Docket Nos. ~~50-277~~  
and 50-278

The Commission has issued the enclosed Amendment No. 116 to Facility Operating License No. DPR-44 and Amendment No. 120 to Facility Operating License No. DPR-56 for the Peach Bottom Atomic Power Station, Units 2 and 3. The amendments consist of changes to the Technical Specifications (TSs) in response to your letter dated June 13, 1985, as supplemented.

These amendments allow spent fuel pool storage capacity expansion from 2,608 to 3,819 for each Unit's spent fuel pool. The expansion is to be achieved by reracking with newer higher density racks.

ENVIRONMENTAL ASSESSMENT  
BY THE OFFICE OF NUCLEAR REACTOR REGULATION  
RELATING TO THE MODIFICATION OF THE  
SPENT FUEL STORAGE RACKS  
FACILITY OPERATING LICENSES NOS. DPR-44 AND DPR-56  
PHILADELPHIA ELECTRIC COMPANY  
PUBLIC SERVICE ELECTRIC AND GAS COMPANY  
DELMARVA POWER AND LIGHT COMPANY  
ATLANTIC CITY ELECTRIC COMPANY  
PEACH BOTTOM ATOMIC POWER STATION, UNITS 2 AND 3  
DOCKET NOS. 50-277 AND 50-278

Figure 3. Three-Dimensional Nonlinear Seismic Model

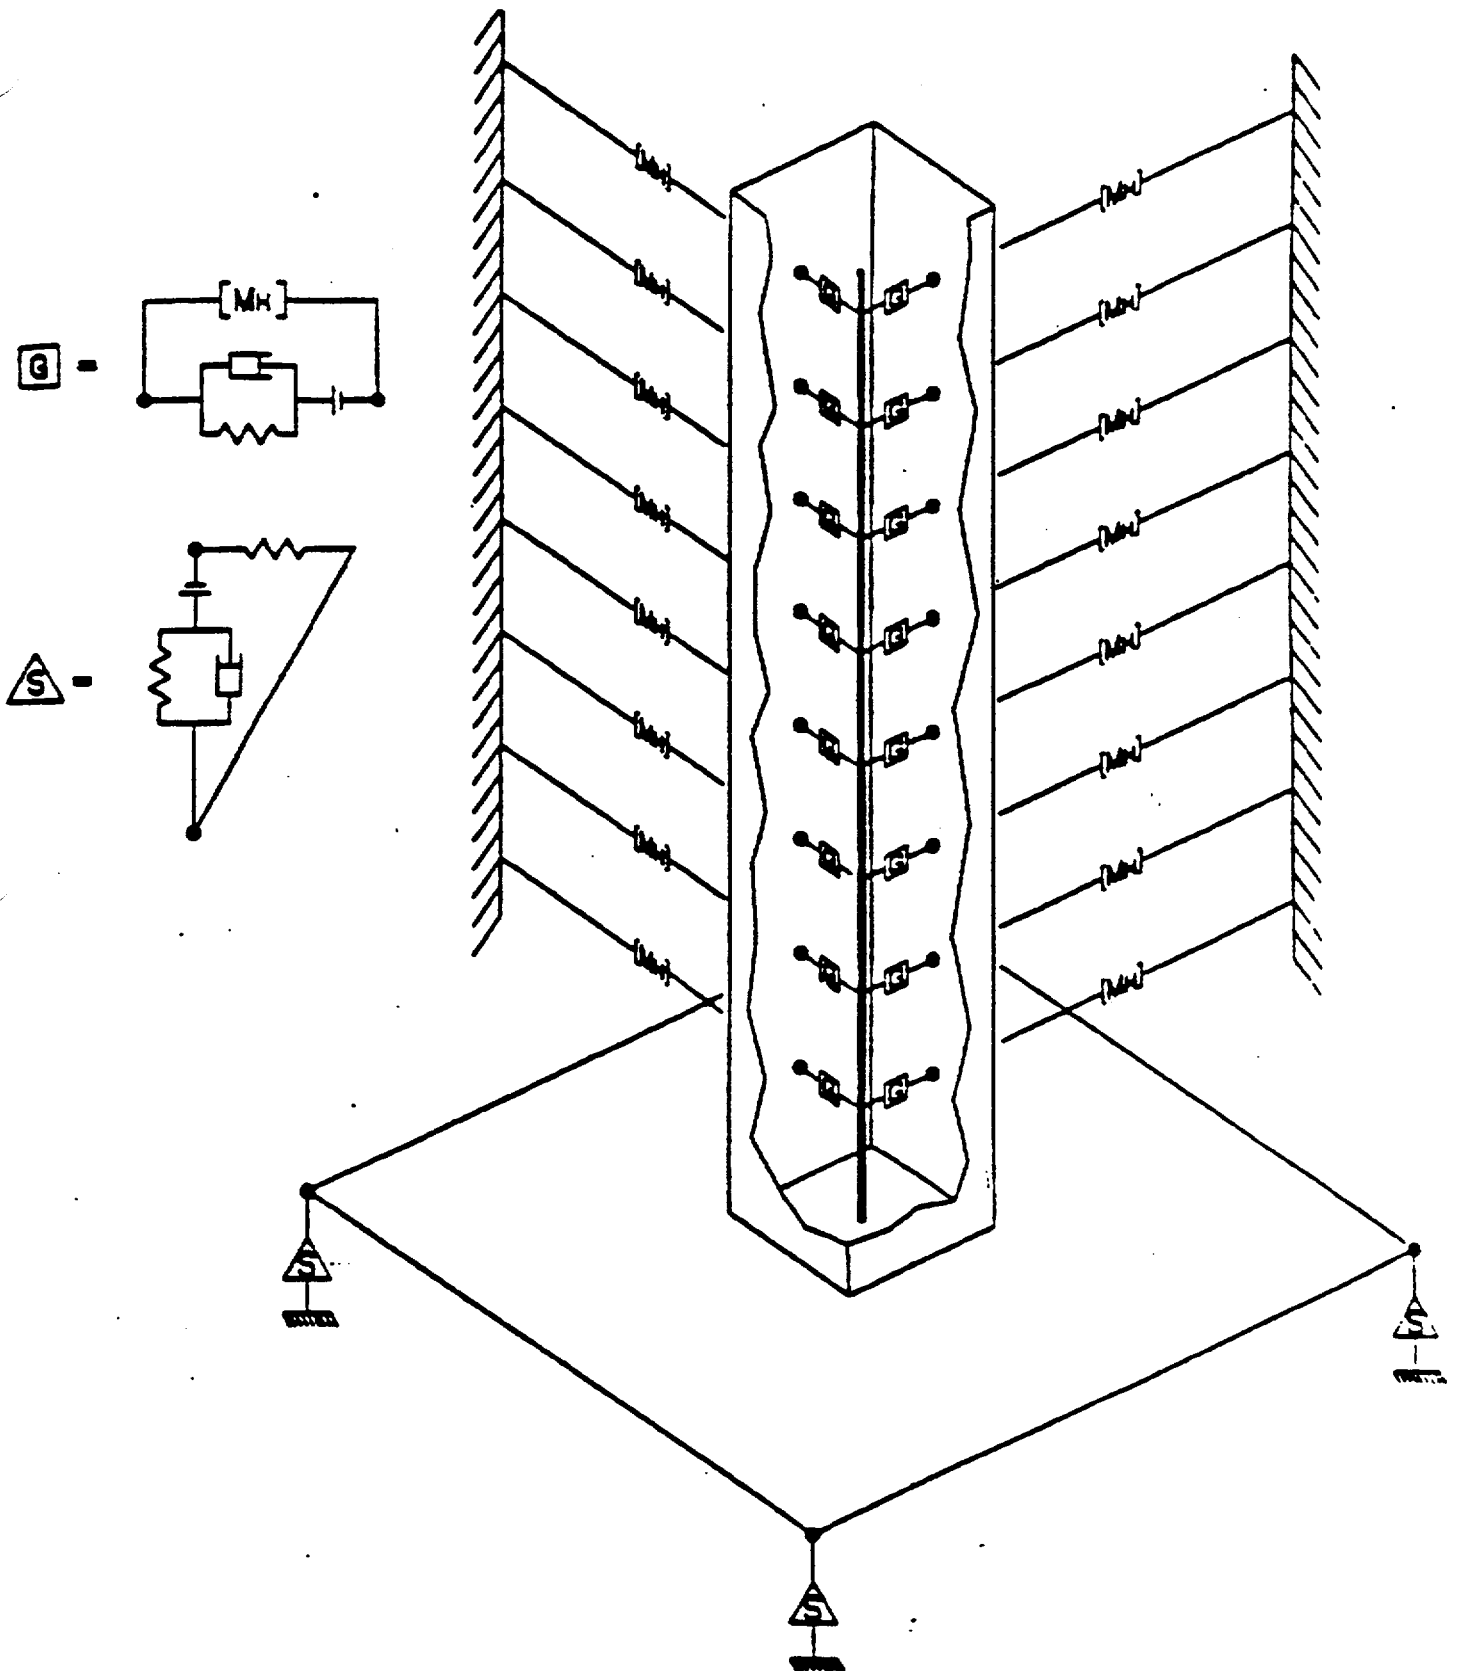
The effective structural properties of the single cell model shown in Figure 3 were modeled by three-dimensional beam elements and were derived from linear three-dimensional analysis of the fuel rack to which the hydrodynamic mass of the water was added. The fuel assembly, modeled by beam elements and represented in Figure 3 by the heavy vertical line, was connected to the cell walls through springs, dampers, gap elements, and hydrodynamic mass of the water in the cell. This model enabled the simulation of fuel assembly motion in the clearance space between the fuel assembly and the rack cell walls, as well as impact with the cell walls.
